DEVIATION REQUEST AND DECISION FORM

Project Name : SF2110: The Hills at Lorson Ranch Filing No. 1

PCD File No. DEV263

A deviation from the standards of or in Section **El Paso County Standard Drawing of the Engineering Criteria Manual (ECM)** **Detail SD 4-20**, is requested.

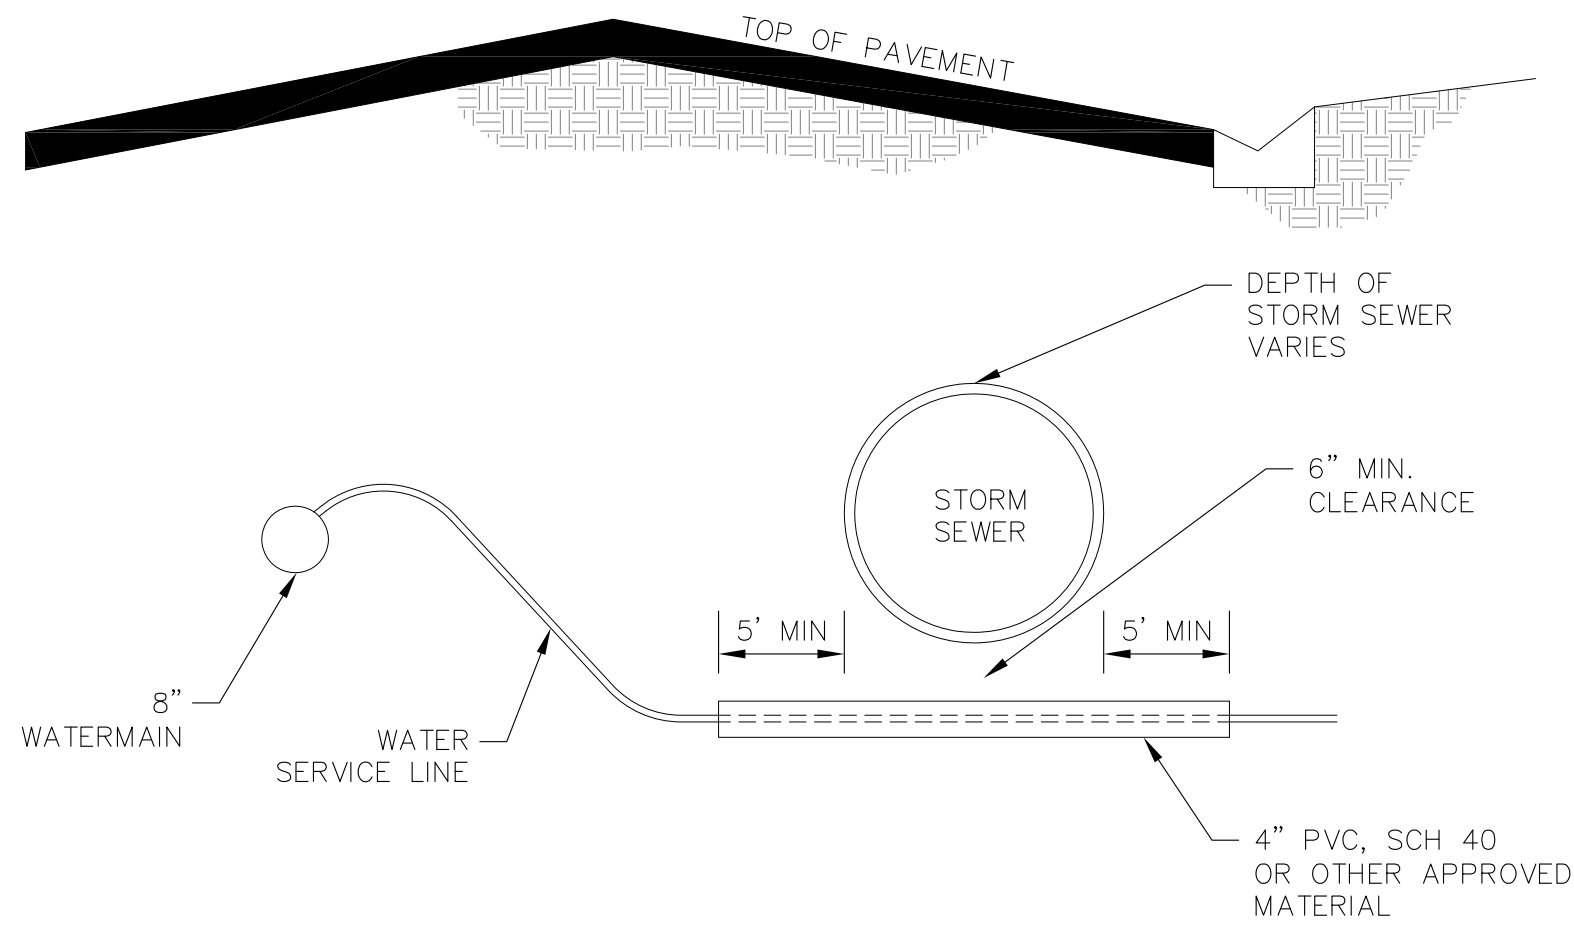
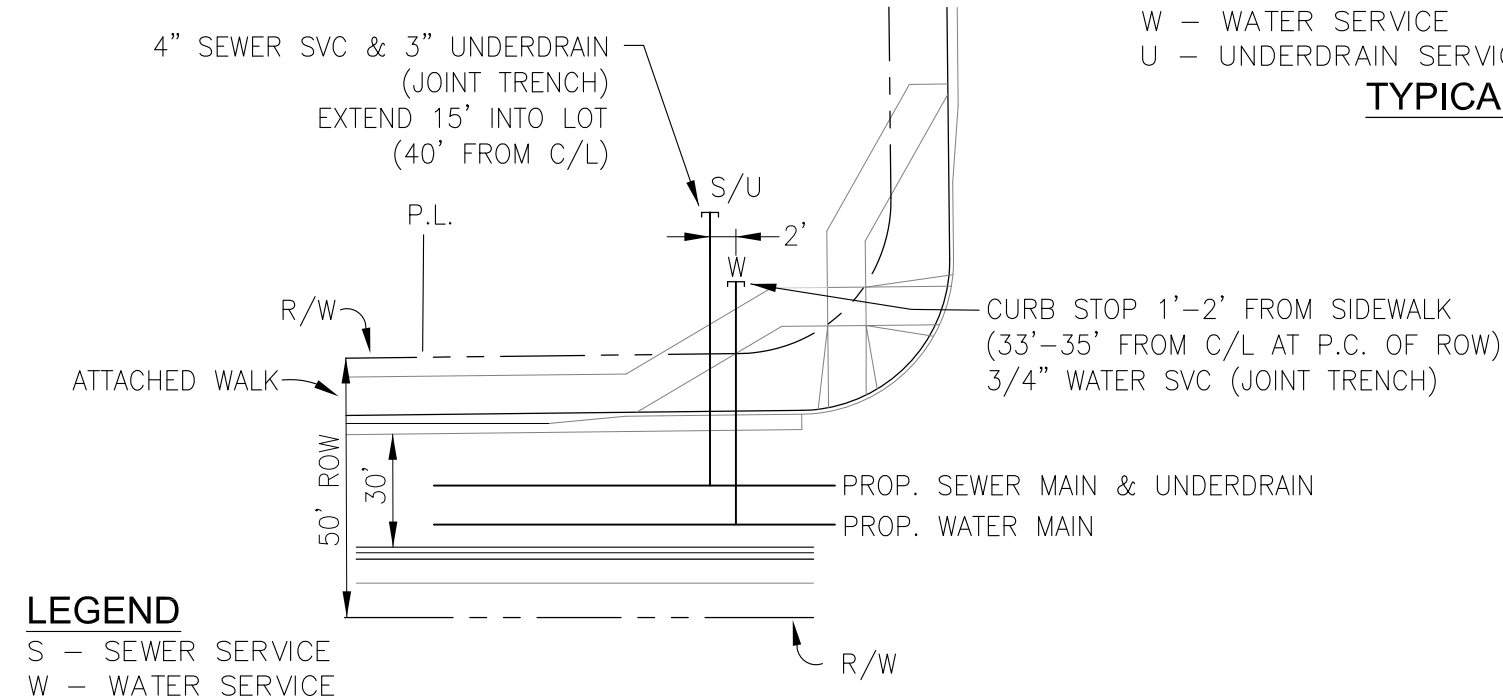
Minimum 1/2" pavement deflection - area to be treated with chemical grout

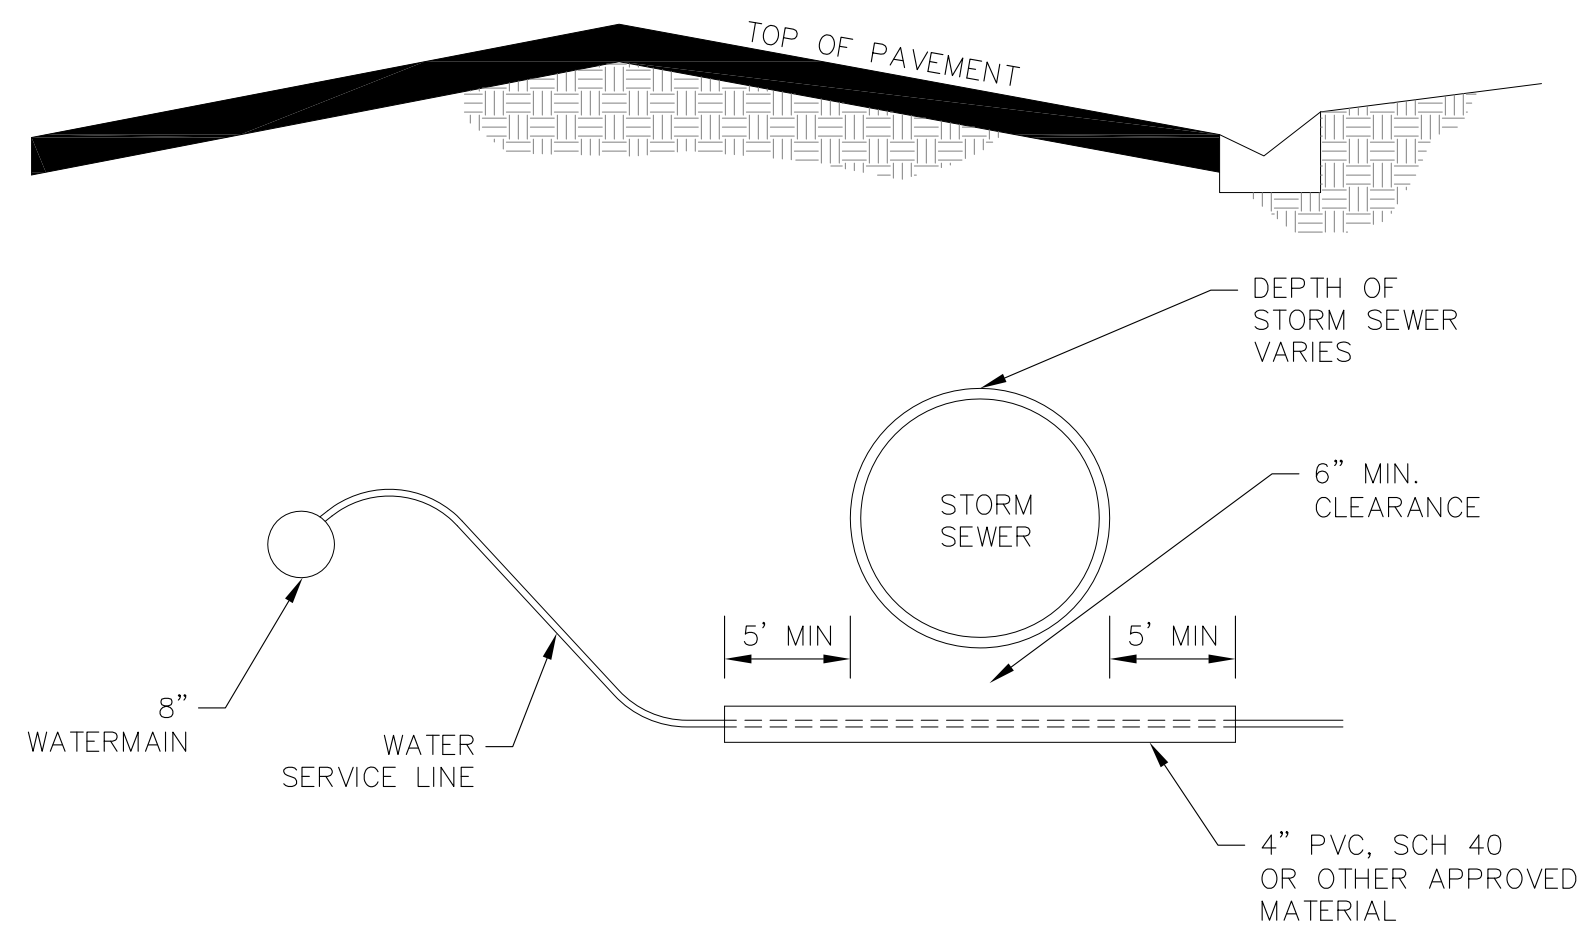
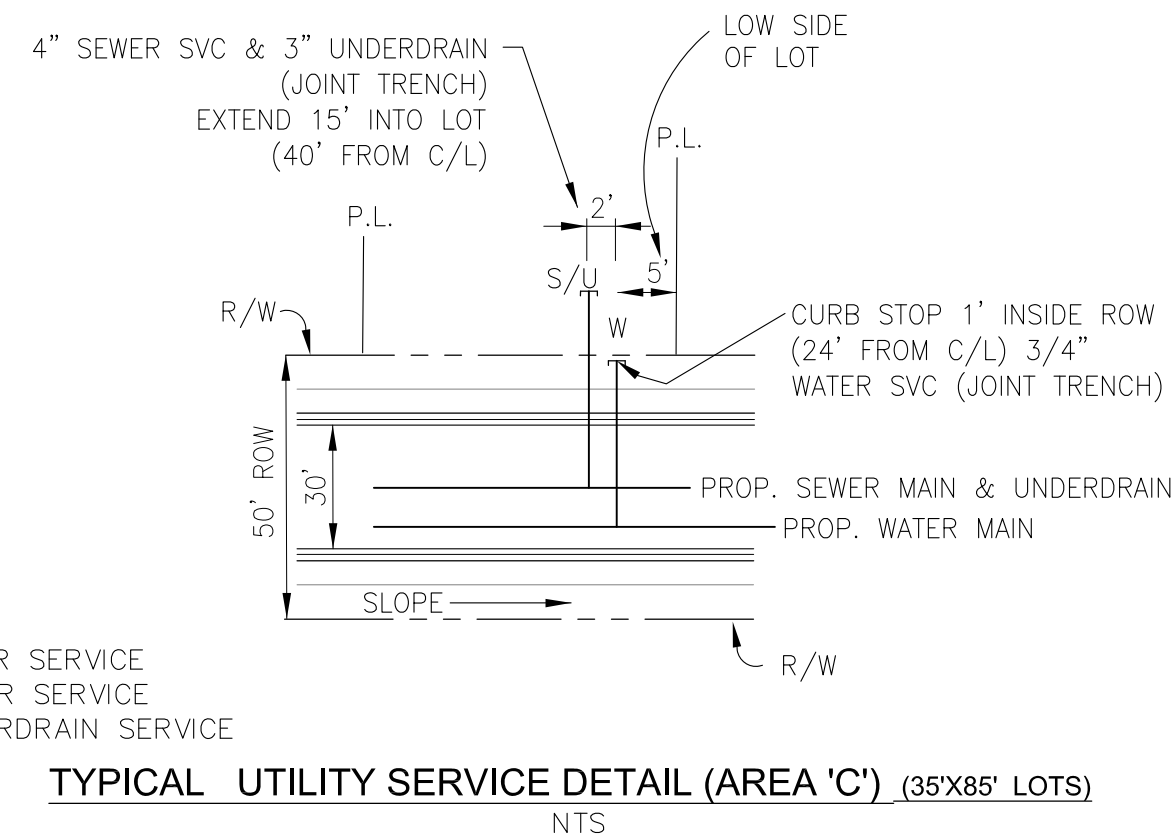
● Minimum 1/2" pavement deflection - area to be treated with chemical grout

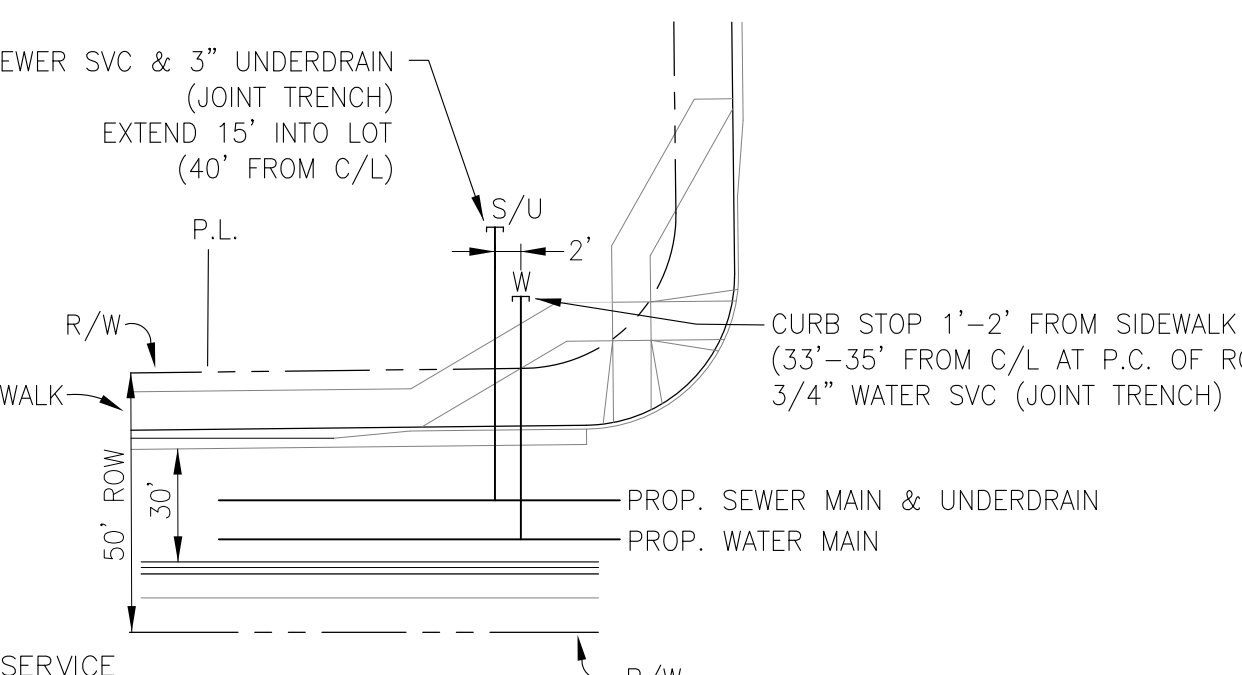
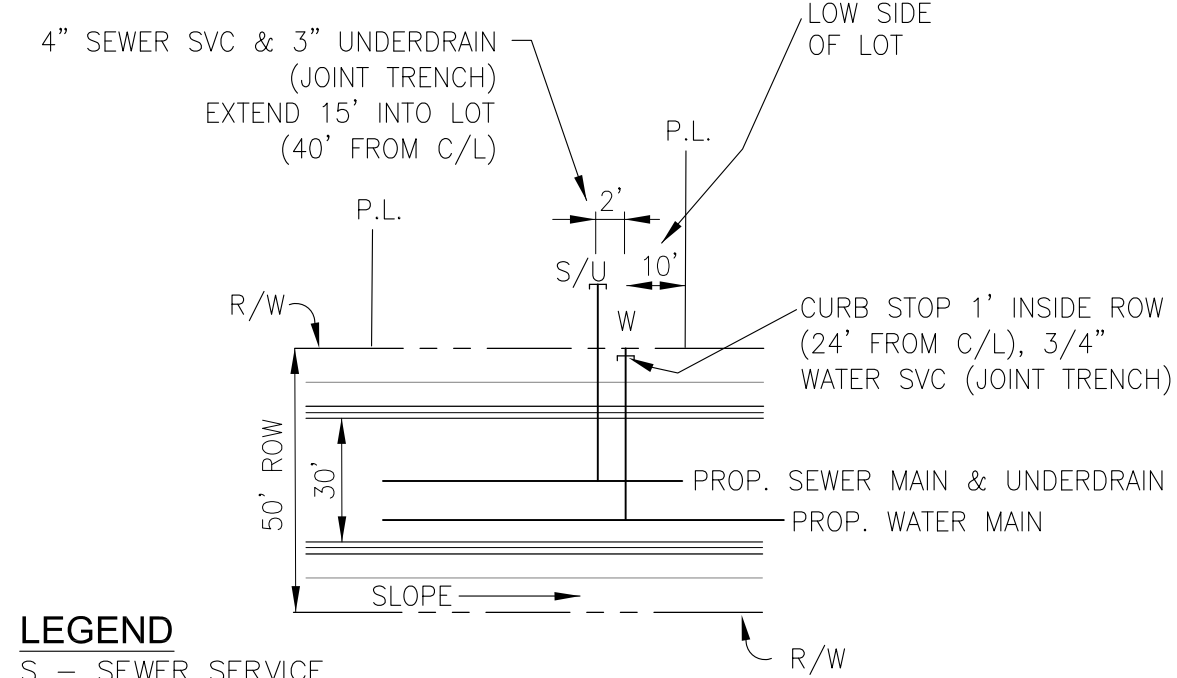
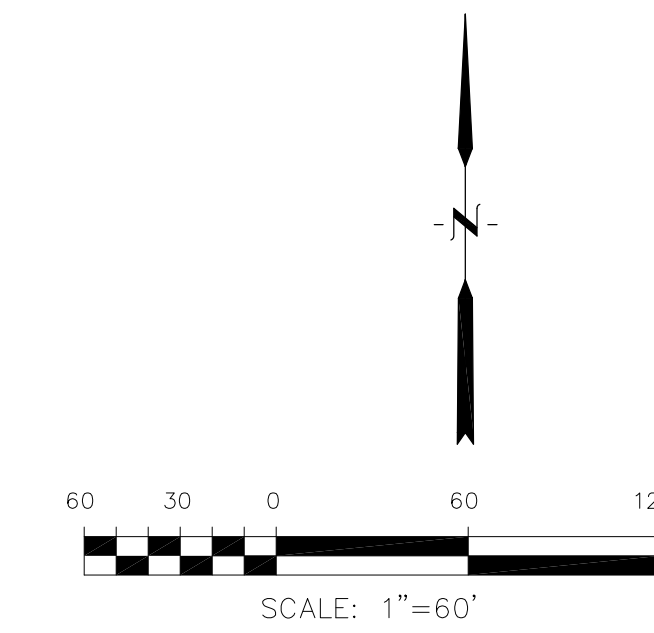
- Minimum 1/2" pavement deflection - area to be treated with chemical grout

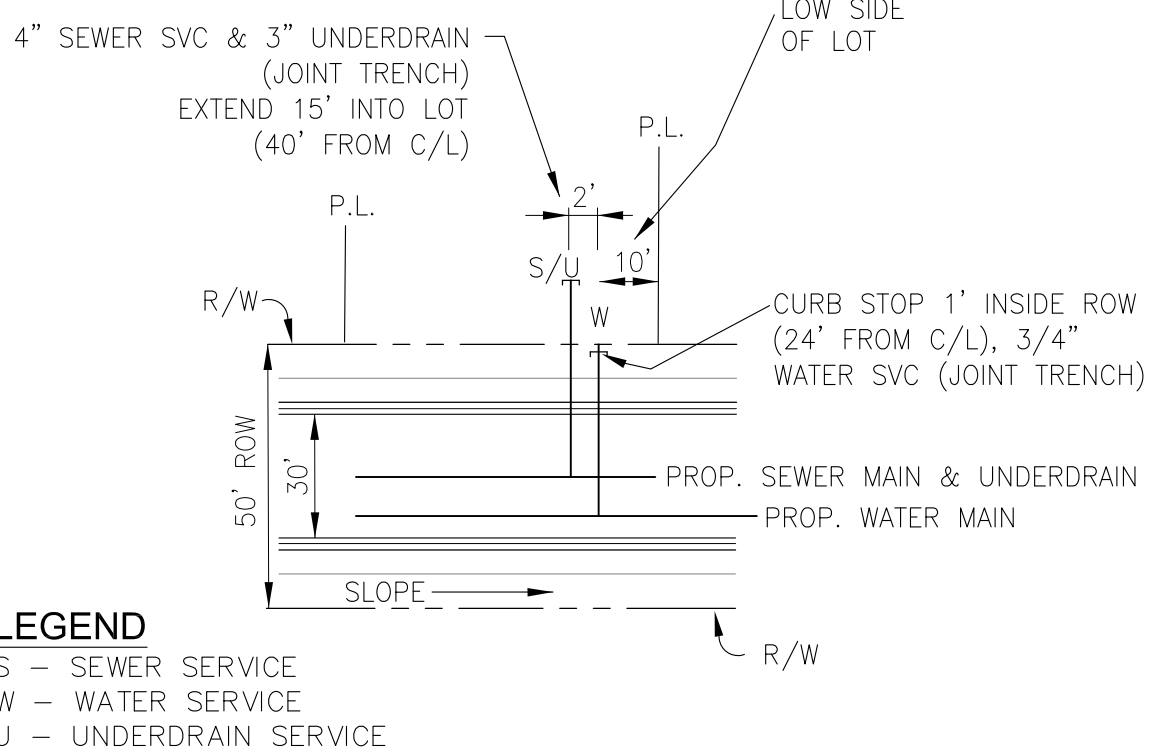
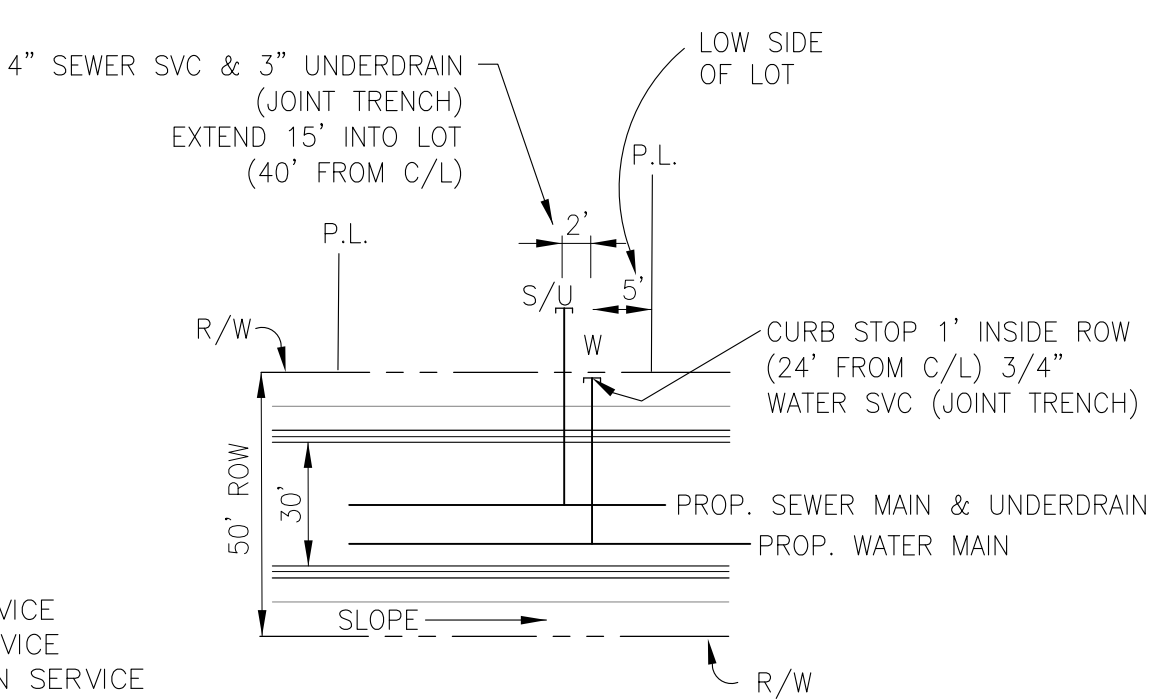
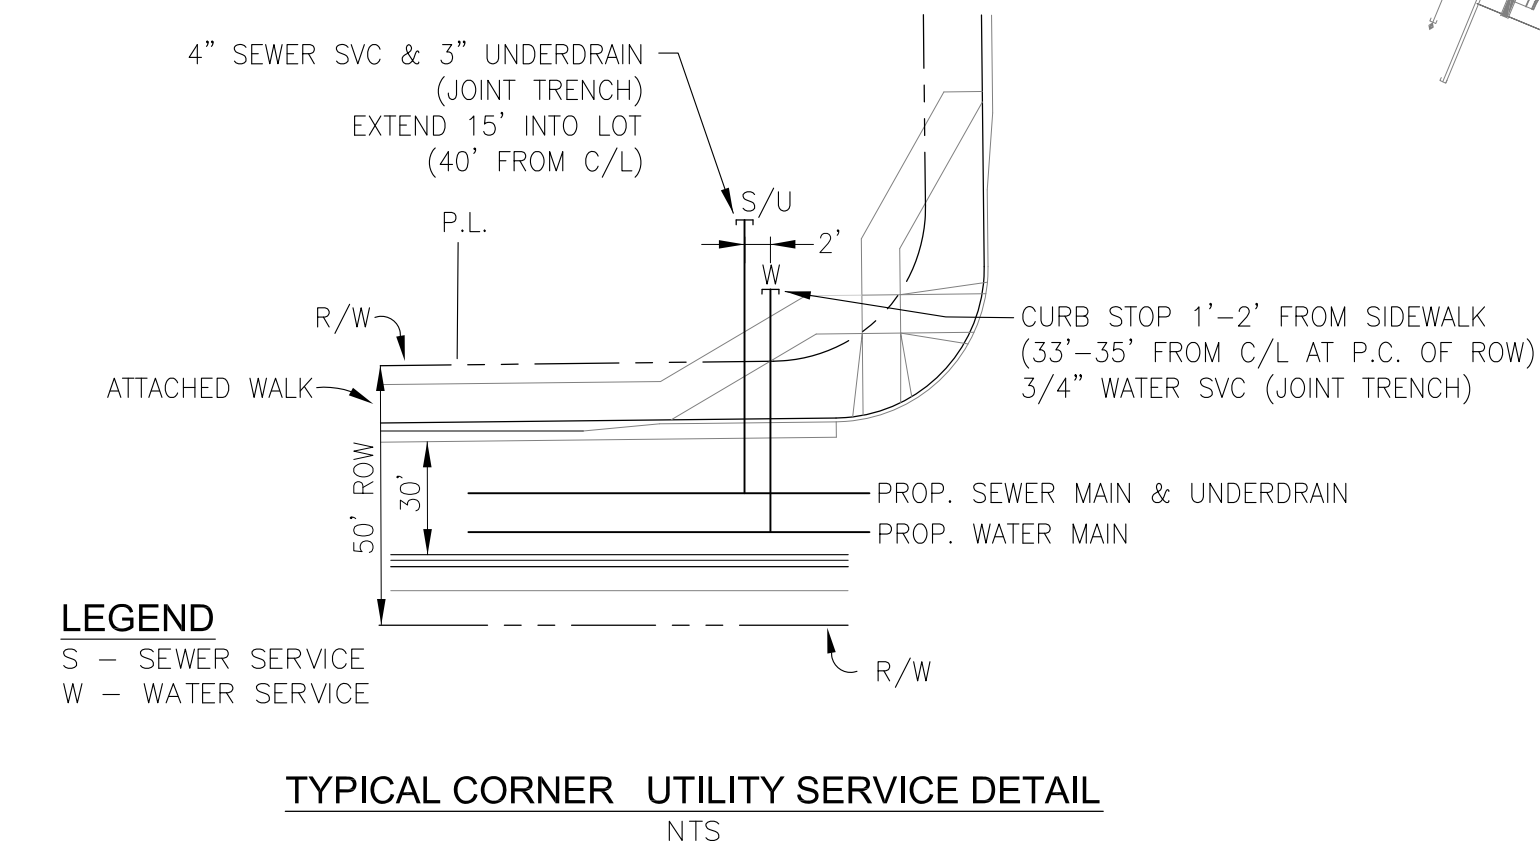
● Minimum 1/2" pavement deflection - area to be treated with chemical grout
